## **ADDENDUM NO. 2**

**DATE:** August 26, 2020  
**FROM:** City of Grand Junction Purchasing Division  
**TO:** All Offerors  
**RE:** 2020 Sewer Line Replacement Project  
IFB-4821-20-DH

# CITY OF GRAND JUNCTION 2020 SEWER LINE REPLACEMENT PROJECT AUGUST 2020

**2020 SEWER LINE REPLACEMENTS  
LAKESIDE SEWER PLAN & PROFILE  
STA 2+42 TO STA 4+50**

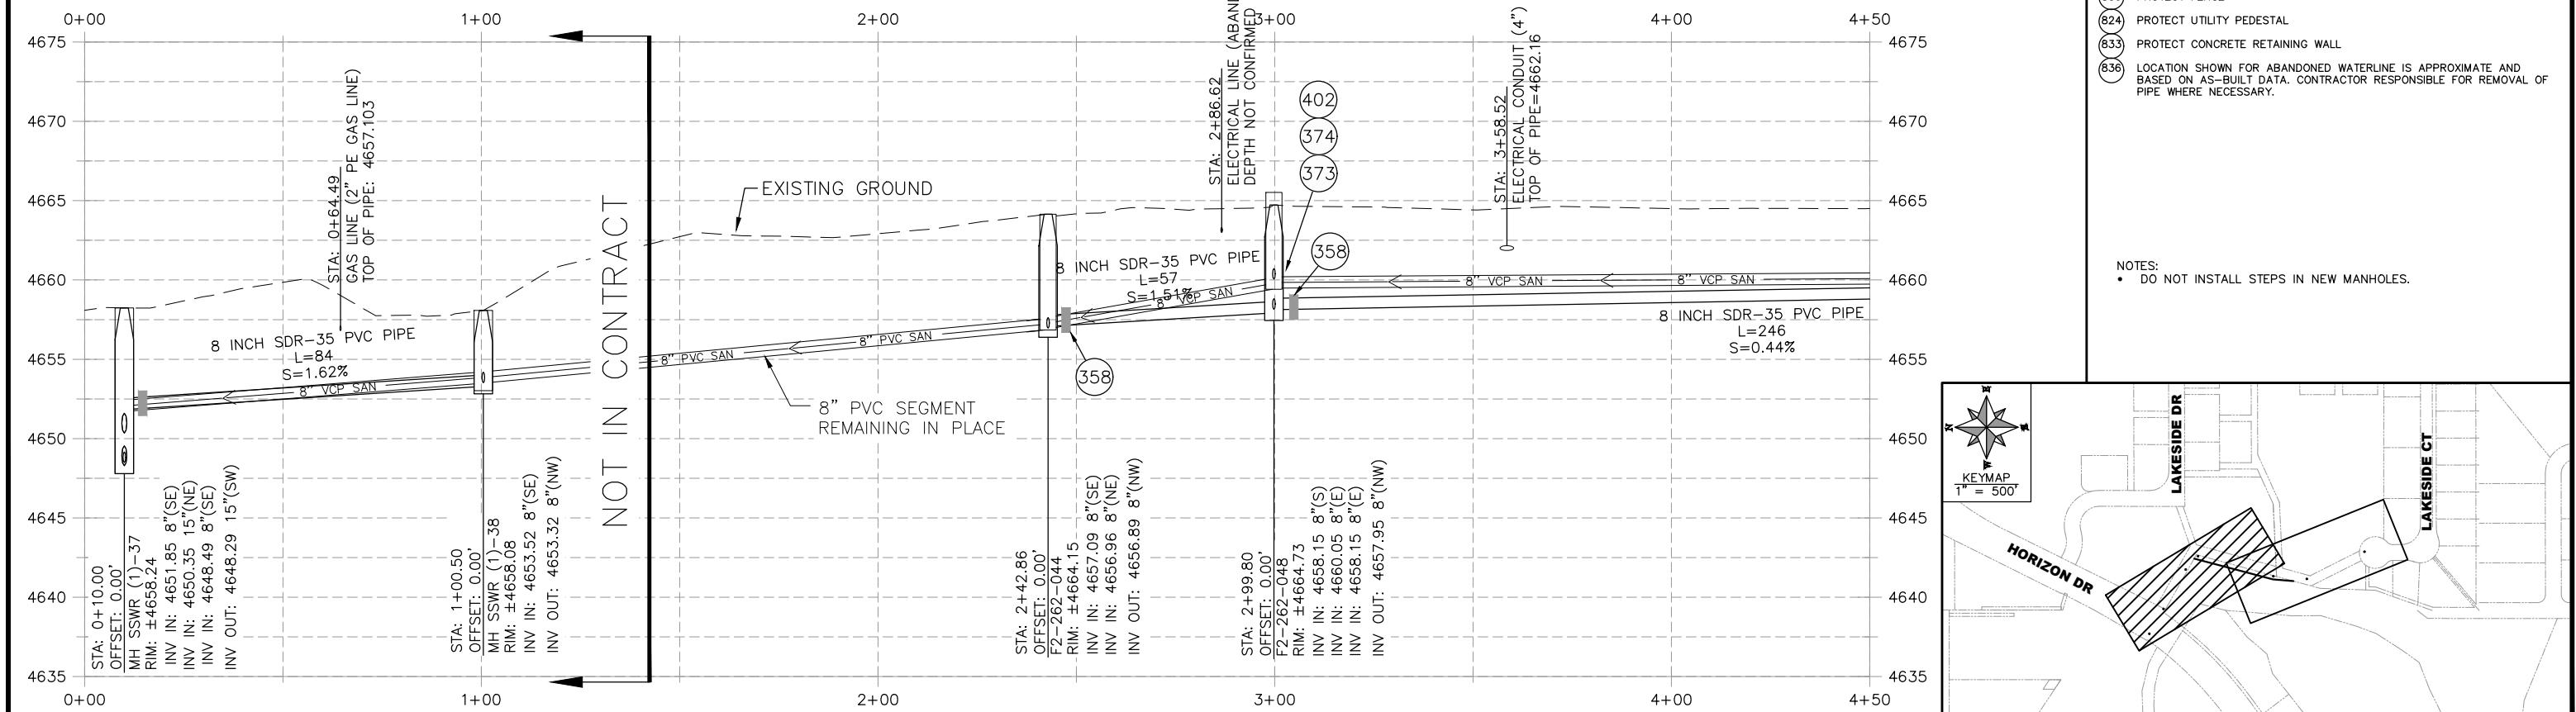
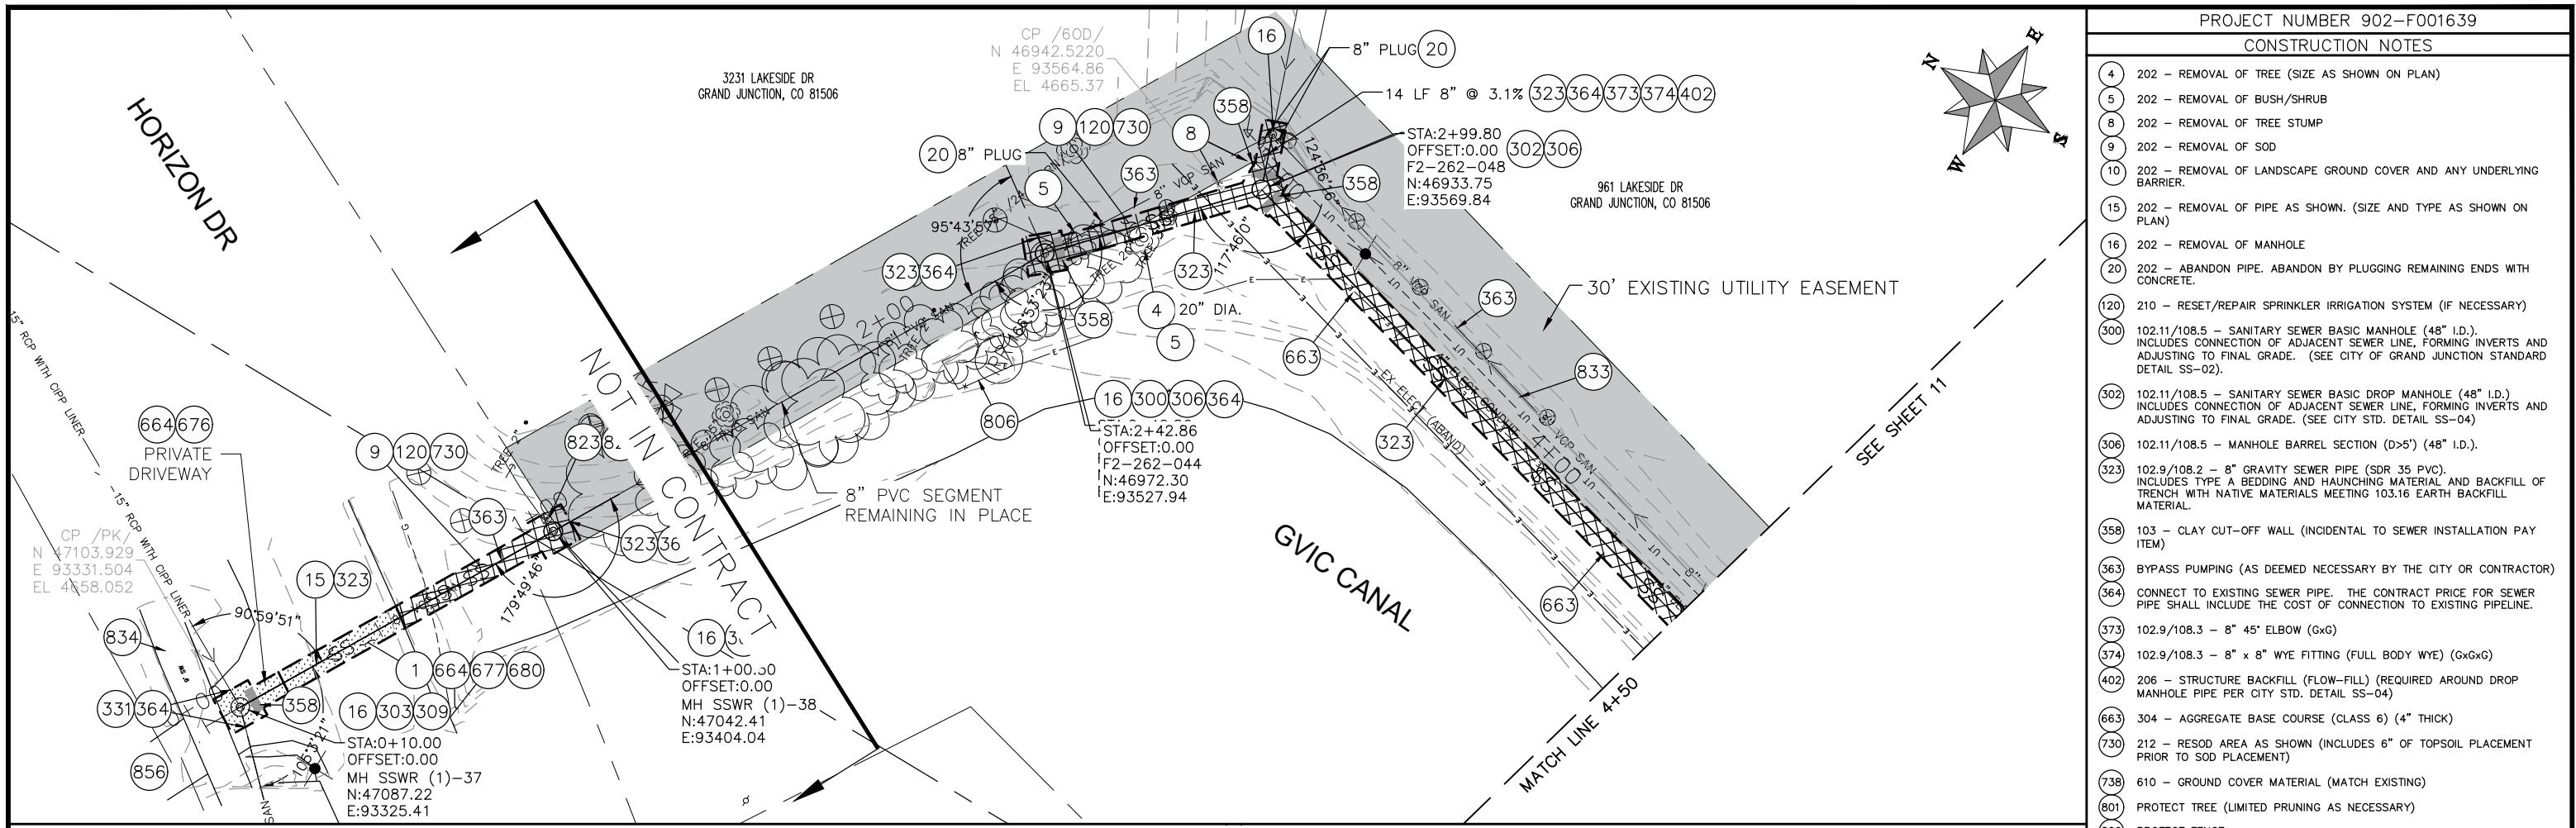
14. Q. Sheet 11 (Lakeside) on the drawings call for note 807 on the top view. However, it is not showing on the actual notes. Please provide the description of Note 807.

15.Q. Sheet 10 & 11 (Lakeside) shows Note 120 to repair sprinkler irrigation system. Please provide layout of what is out there or provide more info on what should be expected to be encountered?

16.Q. Sheet 11 (Lakeside) Note 217 calls for a 24" CMP Storm Drain. Is this to replace the existing pipe? This pipe goes from the Lake Lenore into the existing canal and it seems to be running at full capacity. Is there a time frame when this flow will be reduced or a way to reduce the flow into this pipe? Will bypass be needed?

- A. *Construction note #807 is for Protecting the existing sign. See updated Sheet 11 in the updated construction plans attached to this Addendum #2.*

A. *These are private irrigation systems and the City has no as-built drawings and/or records that show the alignment of the irrigation pipes and sprinkler head locations. The City expects that the Contractor will encounter either PVC or HDPE sprinkler pipe at a depth of 8-inches to 24-inches. The size of the irrigation pipe is unknown and could vary in size from ¾" dia. pipe up to 2" dia. pipe. From the City's site survey, the existing sprinkler head locations are shown where the City Surveyor saw them or found them. The City doesn't guarantee that all sprinkler heads were located during the site survey. The City Inspector and Contractor will need to work together on locating all sprinkler heads and sprinkler pipes that get removed and/or damaged so they can be fixed and/or replaced with equal or better-quality products that are existing.*

A. *The City anticipates that when irrigation water is turned off in the Grand Junction area the flow through this culvert will be dry. Irrigation water is typically turned off at the end of October. Since the Lakeside sewer replacement is to start after the completion of 1<sup>st</sup> Street and Shadow Lake sewer the City anticipates this culvert will be dry. If there is still a small amount of flow going through the culvert later in the year, the Contractor can potentially sandbag upstream of the culvert to stop flows from getting to the culvert.*
